SYDNEY OLYMPIC PARK

Finalisation Report

Review of Master Plan 2030 and *State Environmental Planning Policy (State Significant Precincts)*

November 2017

Parkview Precinct - Site 2A & 2B

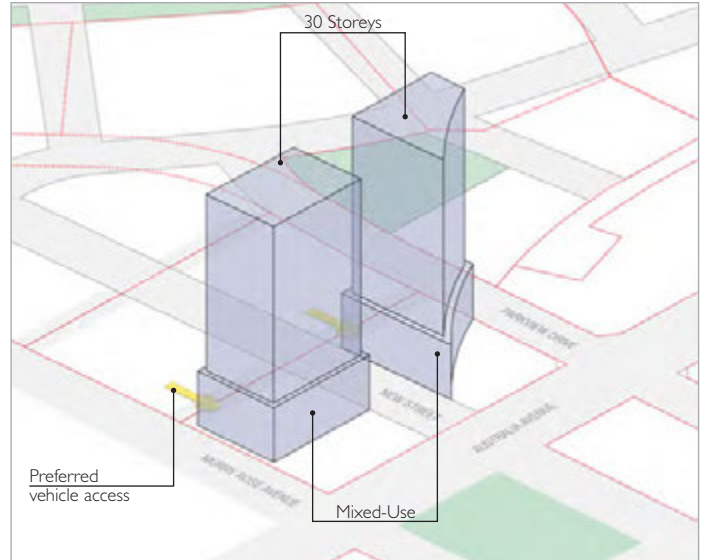
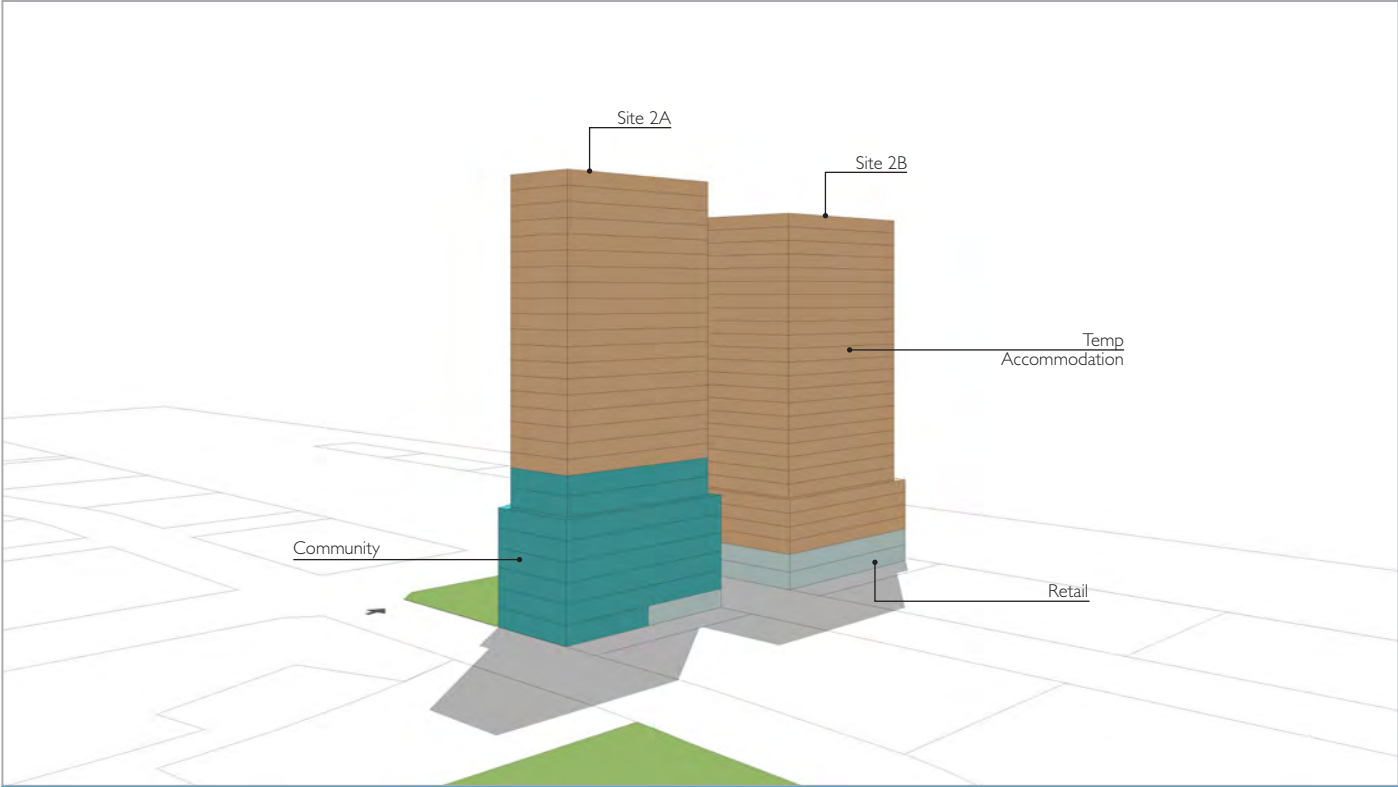
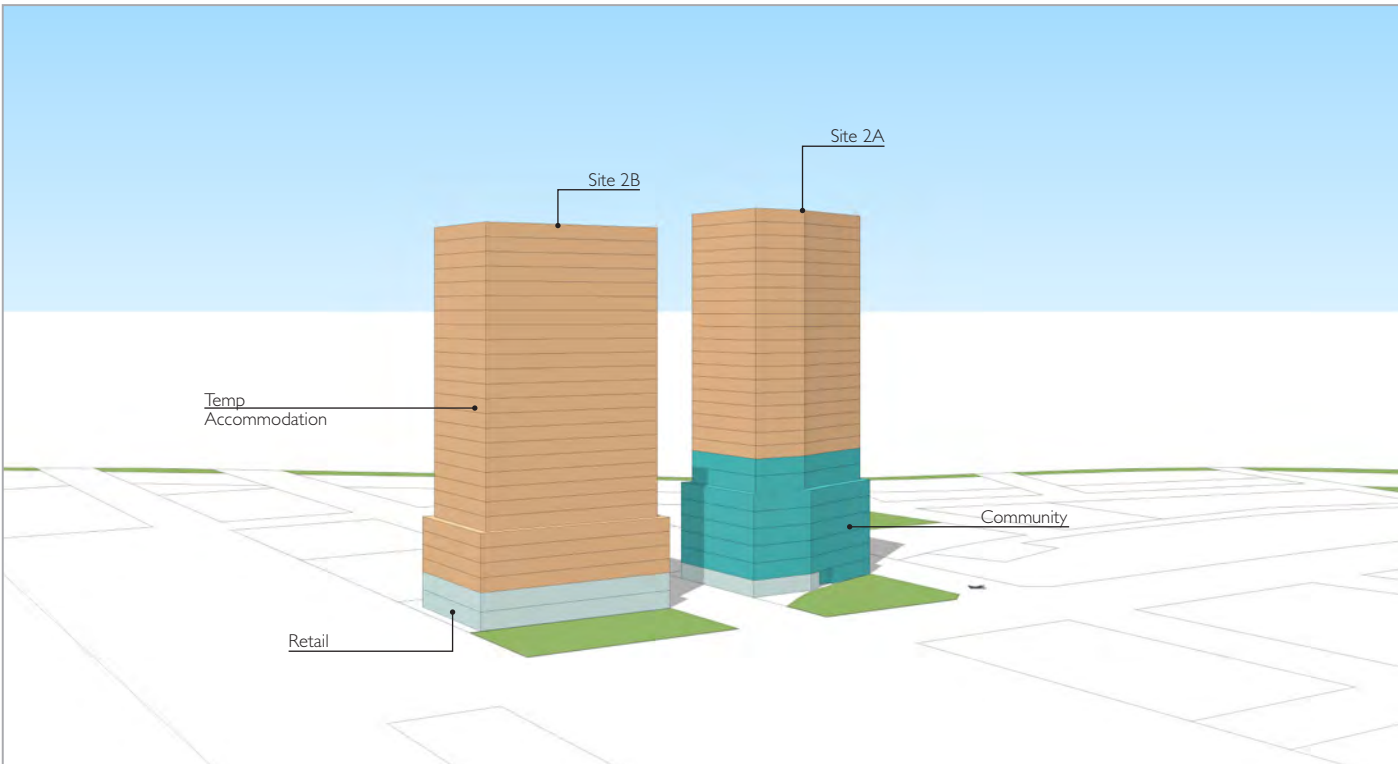
Within that context, Site A (Parking P6) is not considered a development opportunity and Site 2A and 2B has a maximum permissible floor space ratio of 5.5:1 which is consistent with the intention of the Draft and associated infrastructure plan.

The Sydney Metro West has not been planned and amendments to controls that anticipate its delivery within a particular precinct or site would be premature.

The proposed building heights within the Draft considers a transitional height plane to ensure that a certain proportion of solar access is maintained to the public open spaces and active transport corridors within the precinct and that the resultant built form of the precinct is cohesive and coherent.

Parkview Precinct - Site 61A & 61B

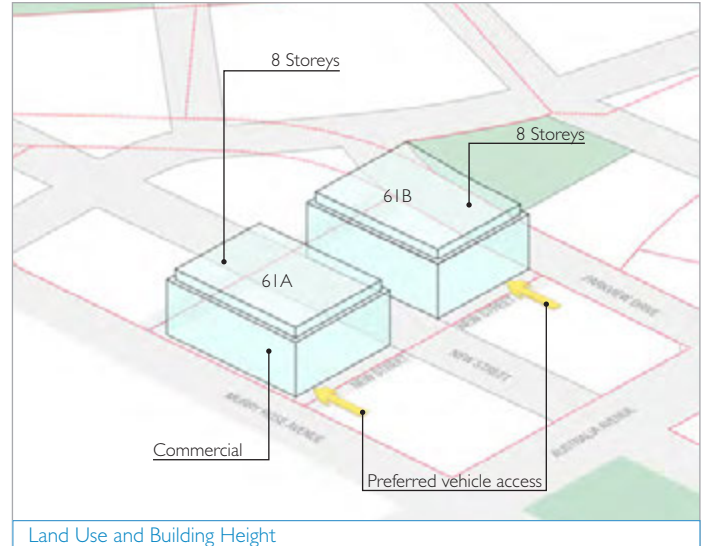
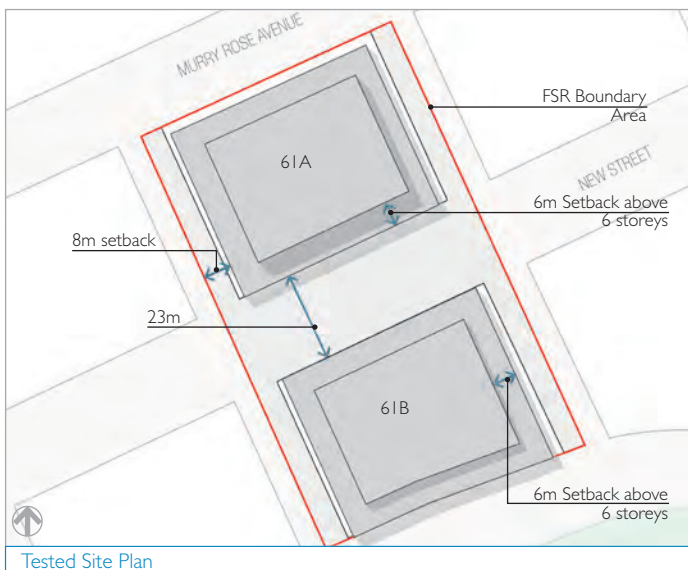
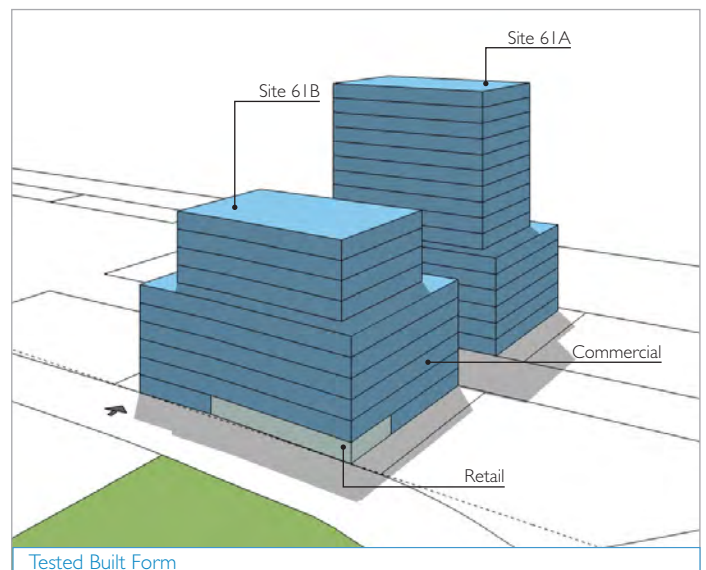
The detailed testing has revealed that, due to a combination of the orientation of the site, the geometry of the site boundaries and the strict adherence to the controls, the site is not achieving the desired targets of GFA and desired mix of uses as proposed within the Draft.

To achieve the targets and mix of uses, in particular commercial, employment-generating floorspace, whilst maintaining the vision and objectives of the Draft the following amendments to Site 61A and 61B are recommended;

- Consideration by the Authority and future owners of the public realm should be given to the provision of integrated basements and basements located underneath the public realm, particularly where new streets and open spaces are provided within a single leaseholding
- Amendment to the height of buildings plan is required to increase the permissible heights from 8 storeys to 20 storeys on Site 61A and from 8 storeys to 10 storeys on Site 61B (to remain consistent with the potential built form of Sites 62A and 62B)
- The Draft State Environmental Planning Policy (State Significant Precincts) Height of Buildings map should be amended from 33m to 84m for site 61A and 33m to 44m for Site 61B to allow for a maximum of 4m floor-to-floor heights for future A-Grade office space (allowing 4m for plant and lift overruns).

Parkview Precinct - Site 62A & 62B

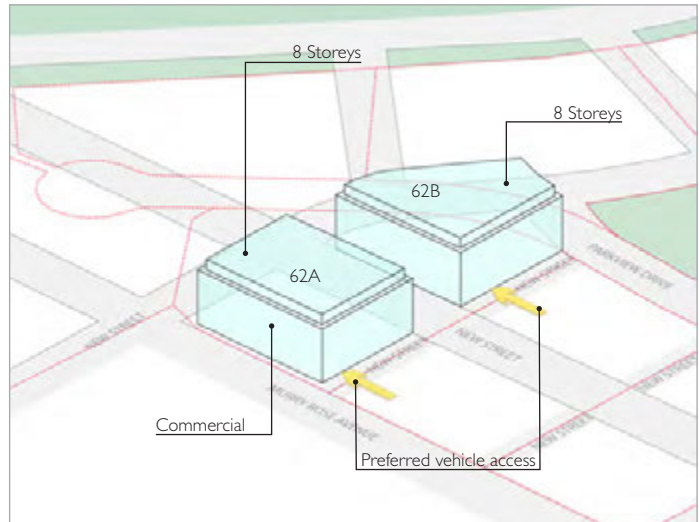
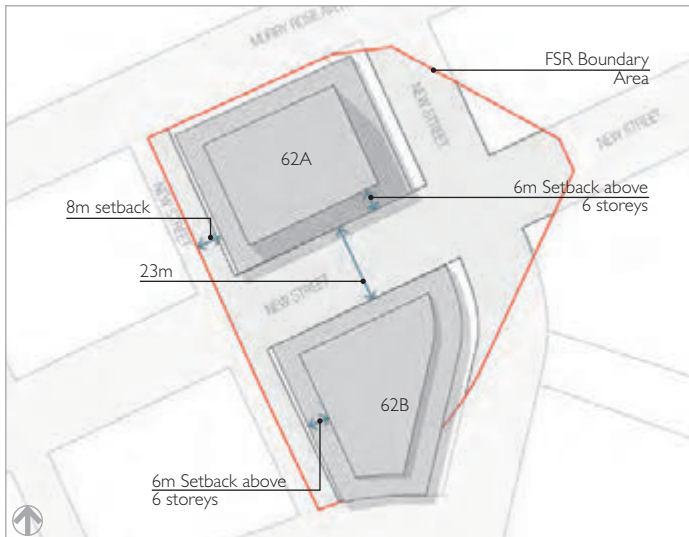
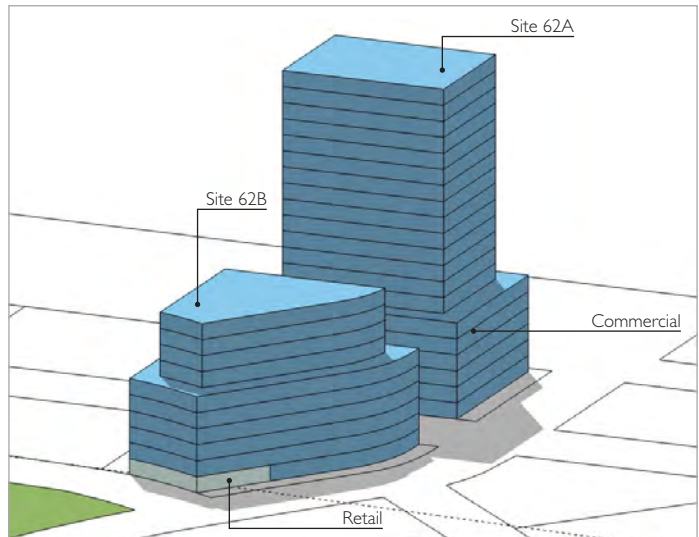
The detailed testing has revealed that, due to a combination of the orientation of the site, the geometry of the site boundaries and the strict adherence to the controls, the site is not achieving the desired targets of GFA and desired mix of uses as proposed within the Draft.

To achieve the targets and mix of uses, in particular commercial, employment-generating floorspace, whilst maintaining the vision and objectives of the Draft the following amendments to Site 62A and 62B are recommended;

- Consideration by the Authority and future owners of the public realm should be given to the provision of integrated basements and basements located underneath the public realm, particularly where new streets and open spaces are provided within a single leaseholding
- Amendment to the height of buildings plan is required to increase the permissible heights from 8 storeys to 20 storeys on Site 62A and from 8 storeys to 10 storeys on Site 62B (to remain consistent with the potential built form of Sites 61A and 61B).
- The Draft State Environmental Planning Policy (State Significant Precincts) Height of Buildings map should be amended from 33m to 84m for site 62A and 33m to 44m for site 62B to allow for a maximum of 4m floor-to-floor heights for future A-Grade office space (allowing 4m for plant and lift overruns).

Parkview Precinct - Site 60A & 60B

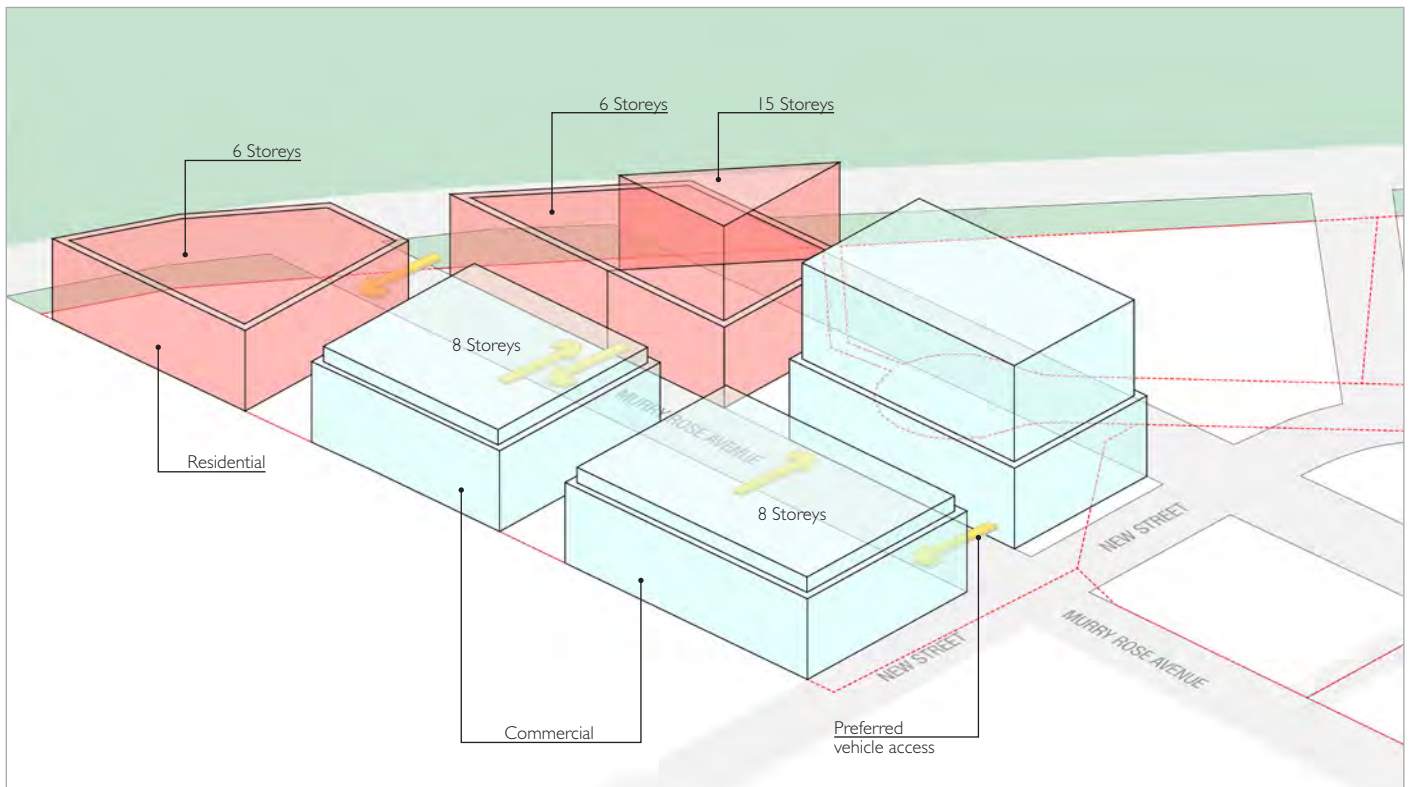
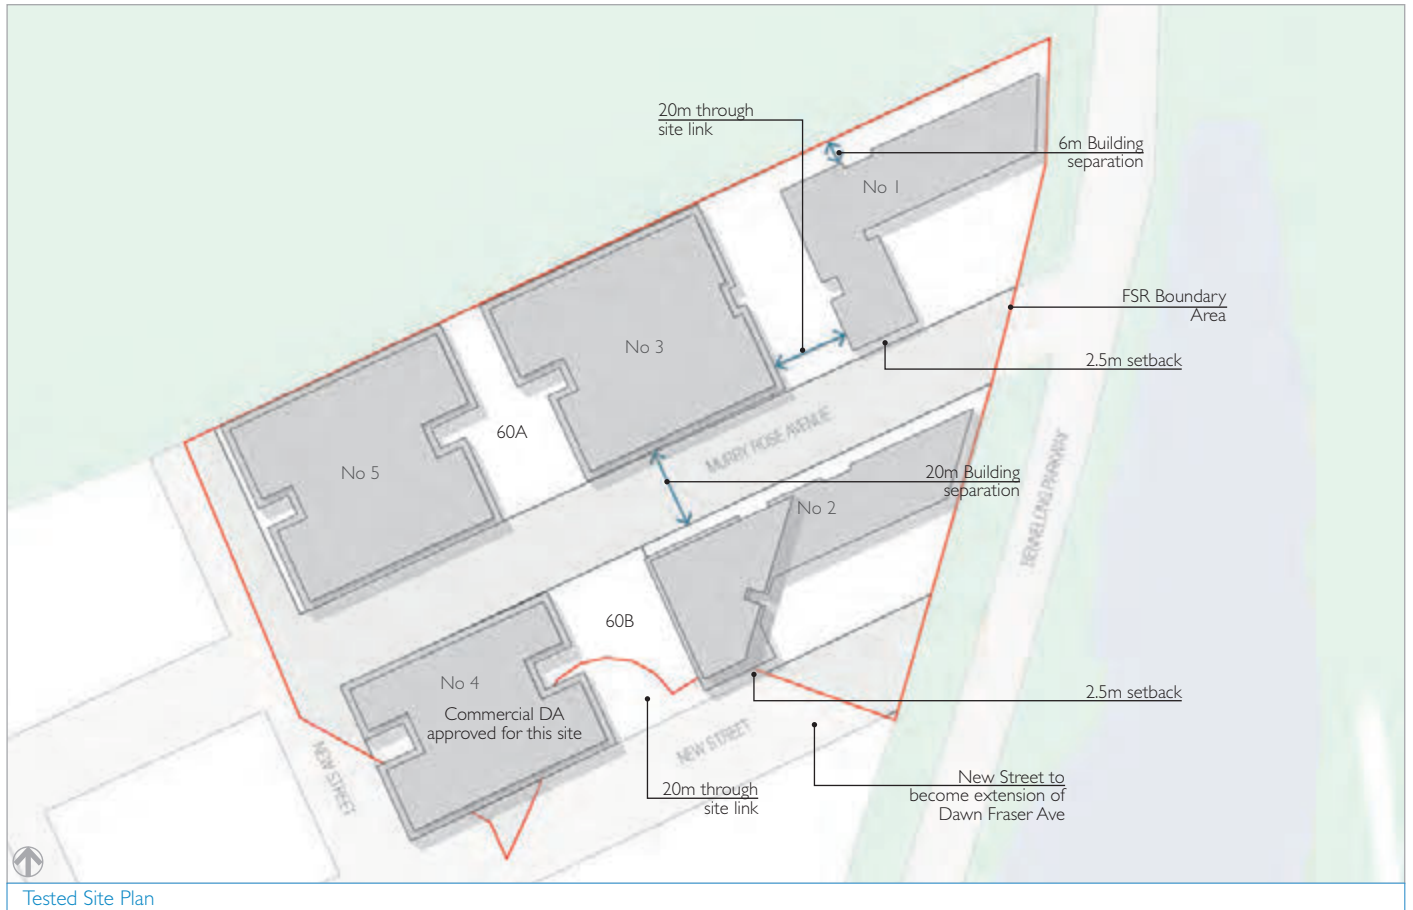
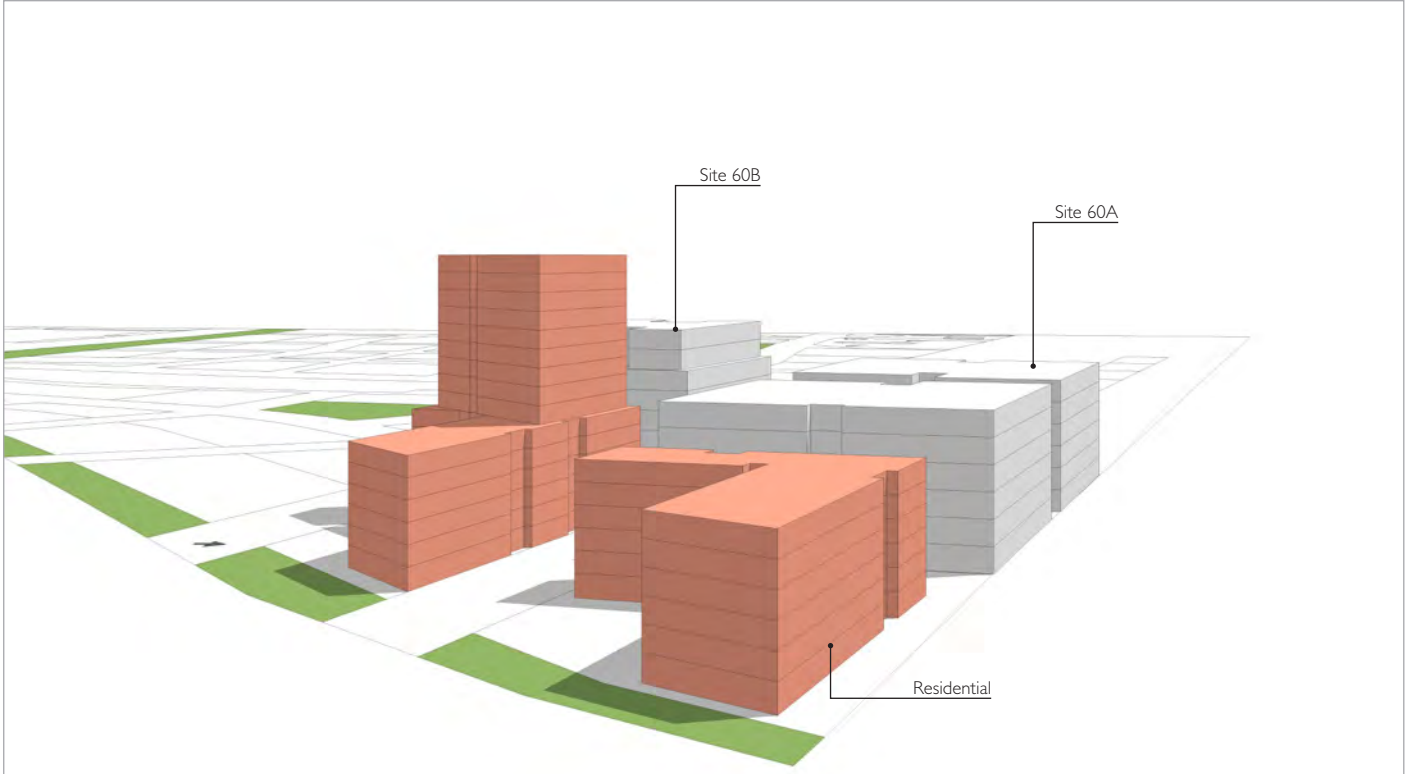
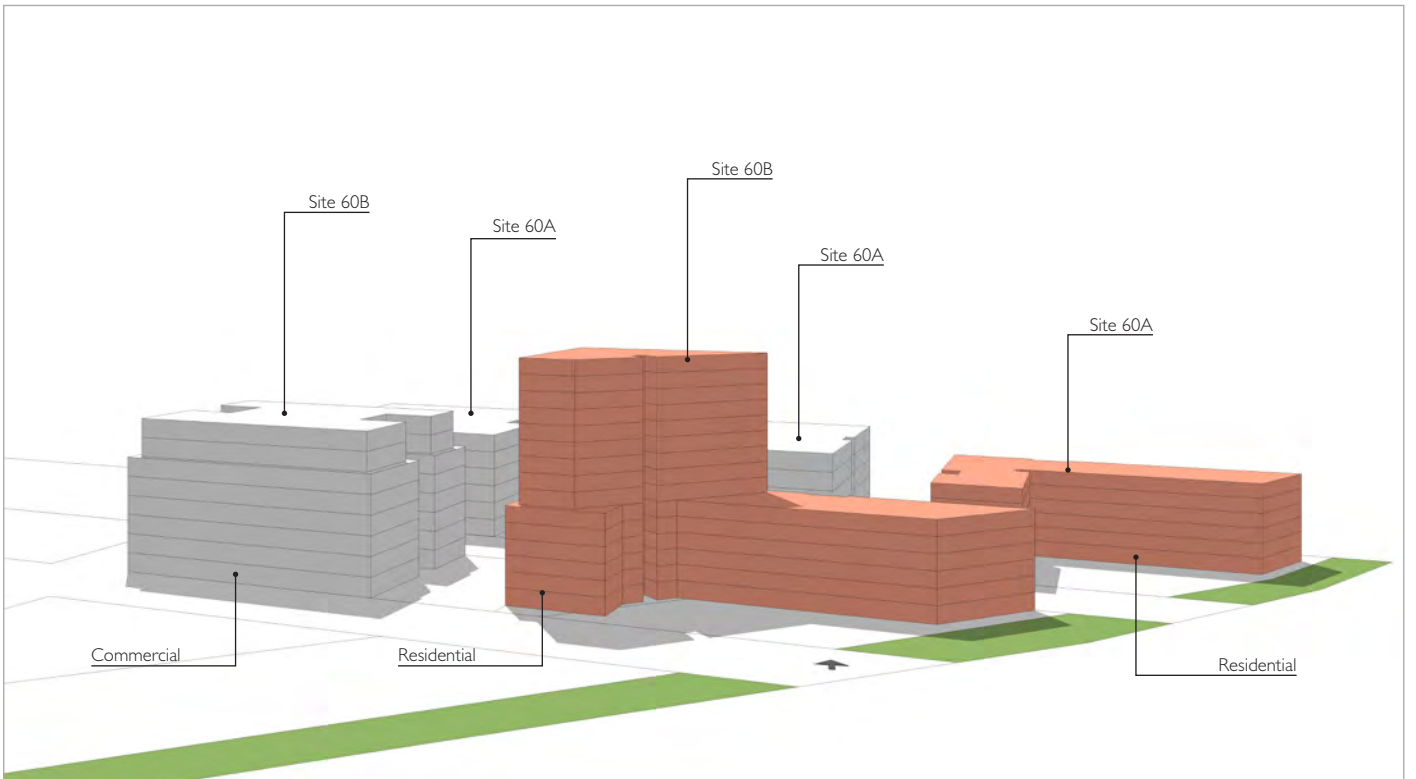
Response: The proposed building heights within the Draft consider a transitional height plane and to ensure that a certain proportion of solar access is maintained to the communal open spaces and public open spaces within the precinct.

Therefore the height controls within the Draft for Site 60A and 60B are deemed appropriate to achieve the required solar access to the linear open space and active transport corridor on Bennelong Avenue.
